Planning Committee

GREATER CAMBRIDGE
SHARED PLANNING

CB1, F2 and B2 (18/1678/FUL)

- Last presented to Planning Committee on 7 June 2020
- Adjourned Decision Protocol (ADP) engaged
- Two minded-to draft reasons for refusal
- Scheme revised and re-consulted upon
- Following extract slides from applicant's Design Document illustrating revisions and comparisons

Key Revisions from Applicant's Design Document

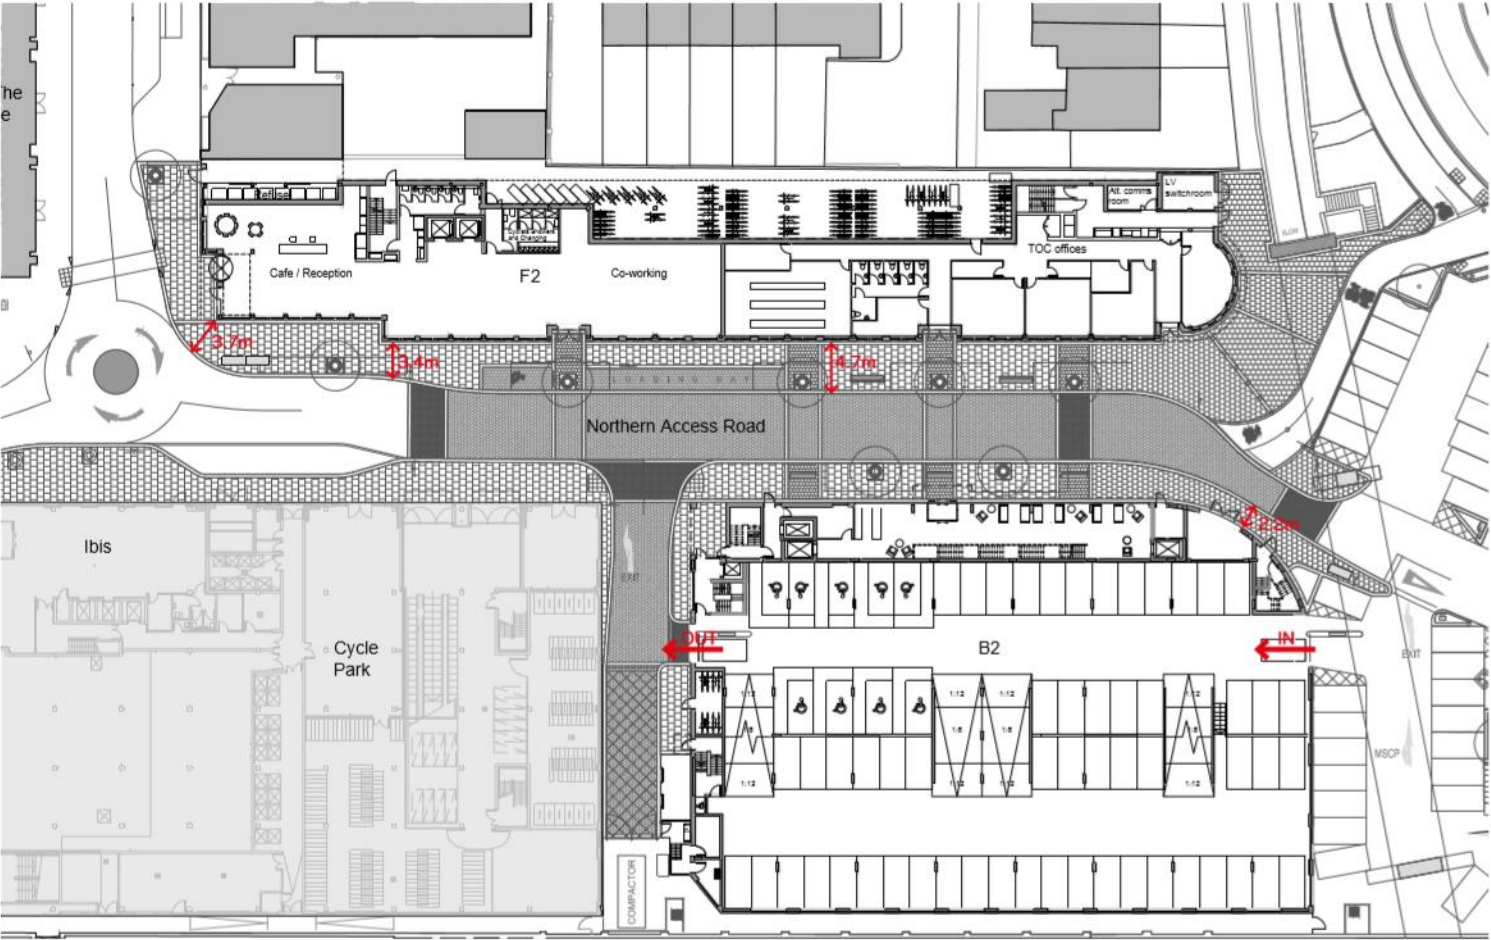
1. Increase the pavement width along block F2 to 5.2m and 5.8m

An increase by 2.9m at the junction with Great Northern Road and 1.9m and 1m along the Northern Access Road eases pedestrian movements along F2 and increases the streetscape physically and visually.

This is achieved by locally recessing the ground floor of F2.

2. Loading bay adjacent to F2

Loading bay demarcation amended with the same paving treatment across the application to provide visual continuity of pedestrian priority.

3. Remove the blue badge parking bay on the pavement adjacent to F2

4. Access and egress to the MSCP reversed to address potential conflicts

The MSCP is now proposed to be accessed from the southern entrance with cars exiting north of the building.

5. Recess the north-western corner of block B2 to widen the pavement to 3.5m

This will improve the pedestrian flow along the building and removal of the parking bay increases the usability and safety travelling north for pedestrians.

Protected Future Route for the Chisholm Trail Access to the Northern Access Road

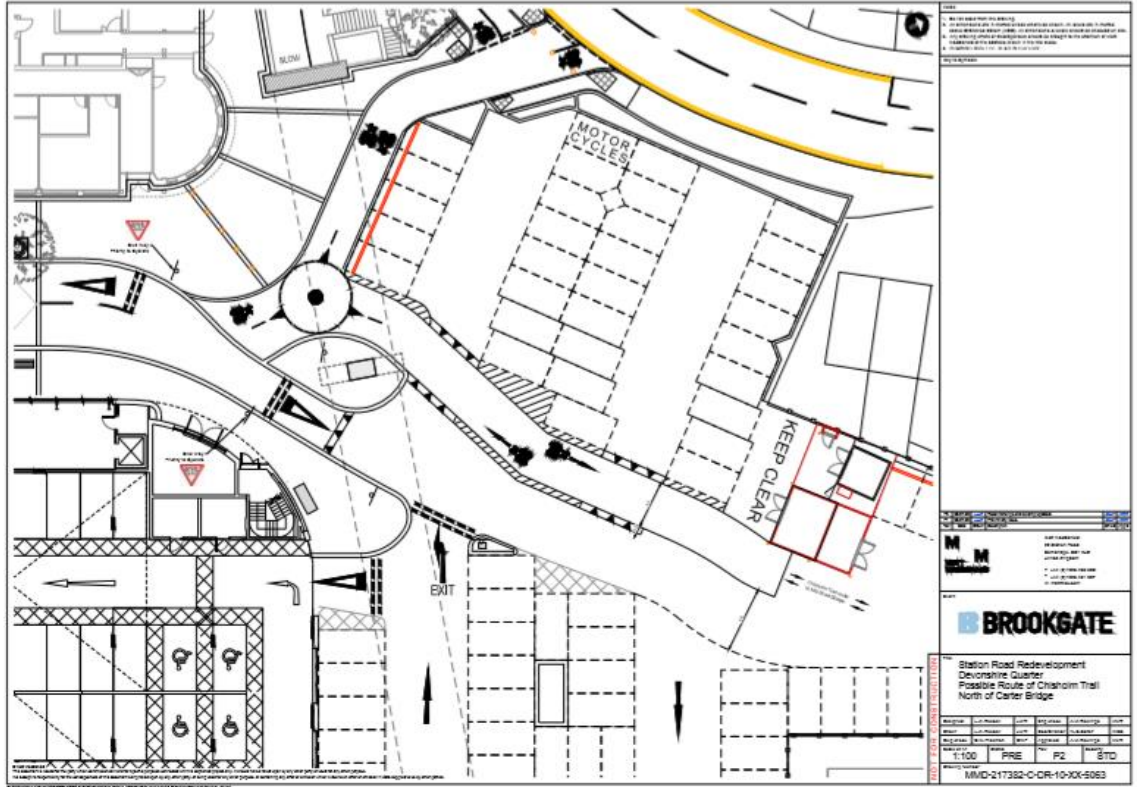
This application does not seek permission for any works related to the Chisholm Trail. Policy 80 is clear in its requirements that the route of the trail should not be prejudiced by development, the route around the Station and toward Devonshire Road is indicative and the County and other stakeholders have a number of legal and practical hurdles to overcome to deliver it. Brookgate have no control over that.

What our indicative plan shows is that the route is not prejudiced in any way, we are therefore policy compliant. The proposal protects the future inclusion of the Chisholm Trail.

Comparison of the Consented and Proposed Footprint of Building B2

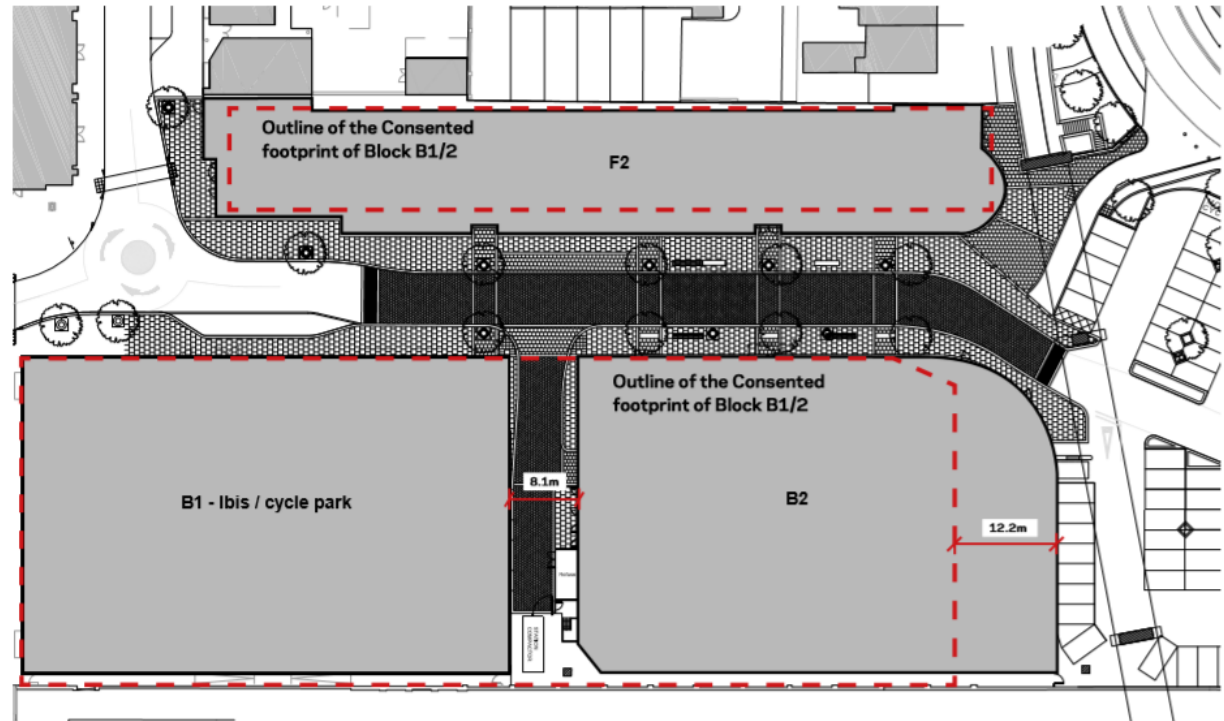
The below diagram compares the consented with the proposed footprint of building B2.

- An 8.1m gap between the Ibis and B2 enables light between the buildings, breaks up the length of the frontage and provides an outlook for the upper floor rooms
- This results in the proposed moving of the building north
- The proposed combined footprint is 17 sqm smaller than the consented footprint (consented: 4,227 sqm, proposed: 4,210 sqm)

These drawings compare the consented and proposed length and height of Building B2. Whilst the building is closer to Carter Bridge it should be emphasised that:

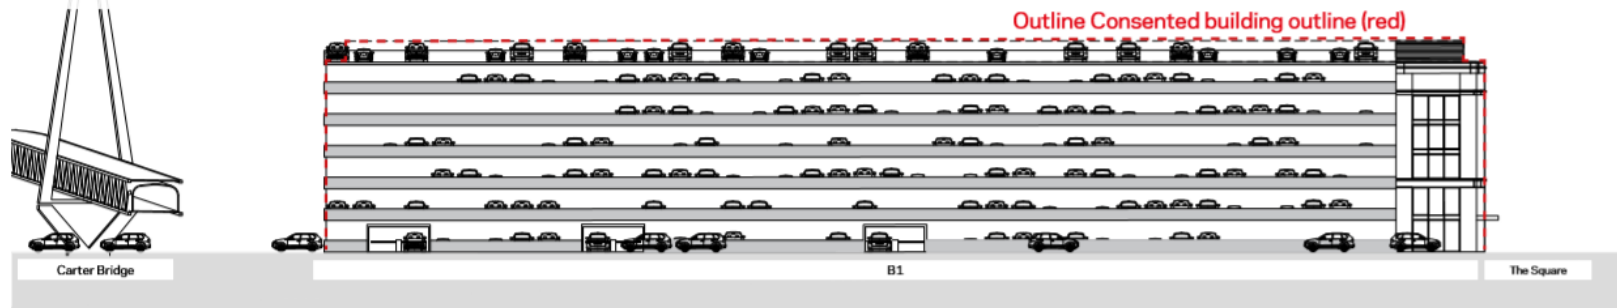
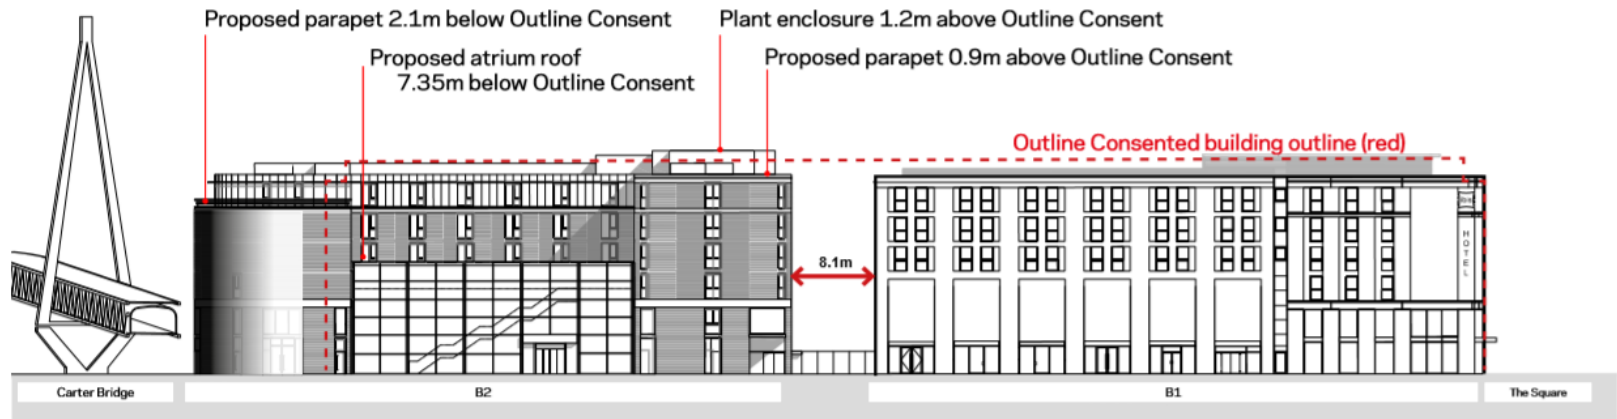
1. The facade benefits from a significantly greater amount of animation than the consented car park facade would have delivered
2. The proposed active frontage delivers a significantly safer and more animated street scene than the blank car park facade would have delivered
3. The break between B1 and B2 permits views and light between the two buildings compared to the 110m long facade of the consented car park
4. The building height steps down towards Carter Bridge and the atrium opens up the street to light and views

Comparison of the Consented Building B1 only with the Proposed Building B2 Looking South along Devonshire Road

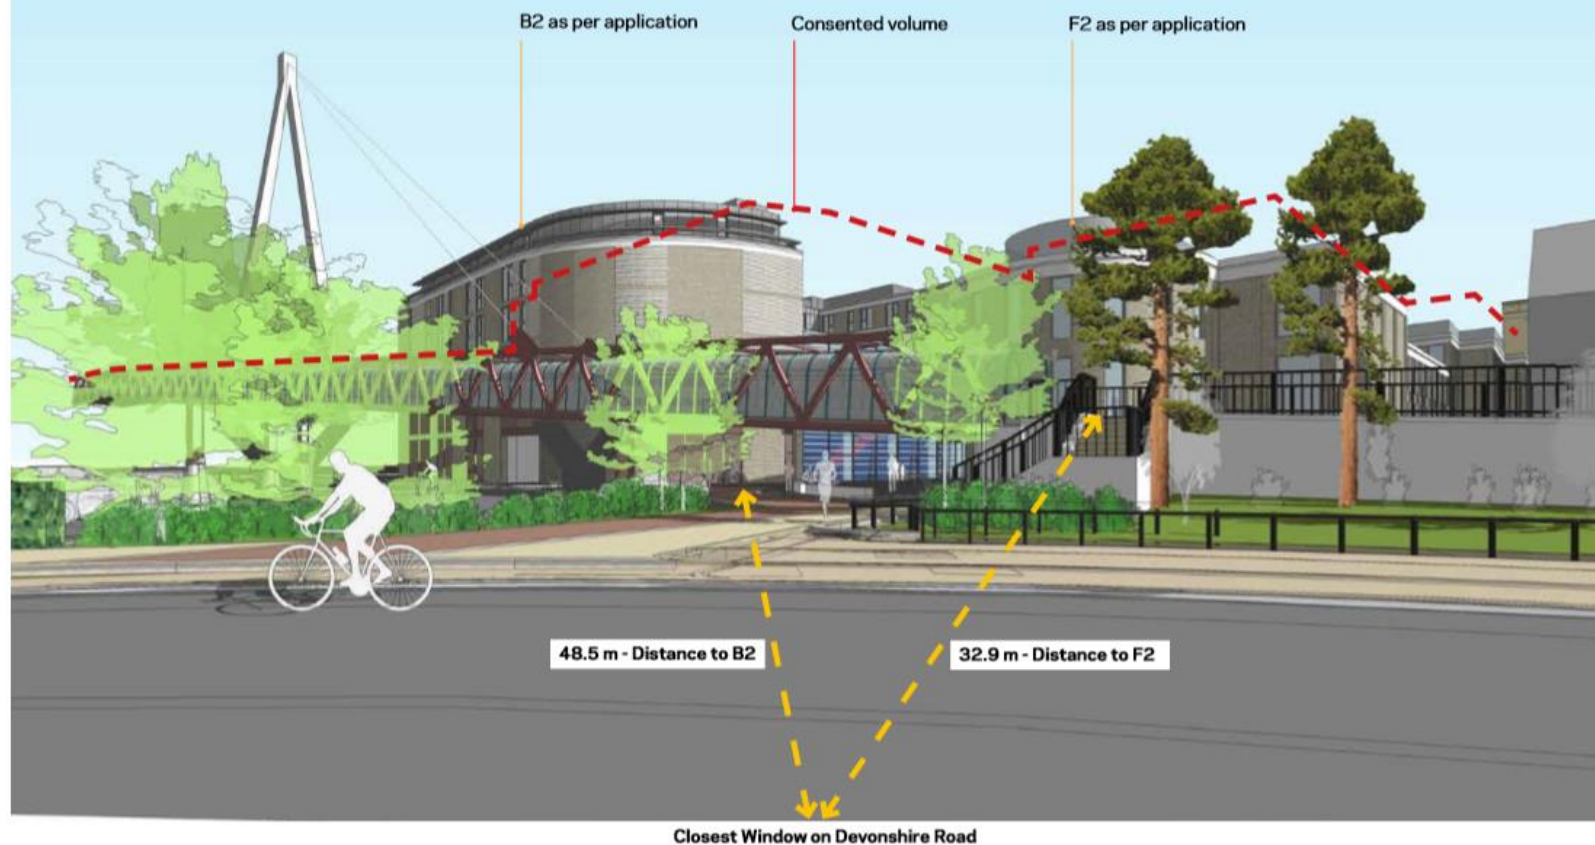
This comparison illustrates that the repositioned block B2 has no negative impact on the view south along Devonshire Road:

- The reduction of visible sky and horizon due to the proposed relocation of B2 is negligible
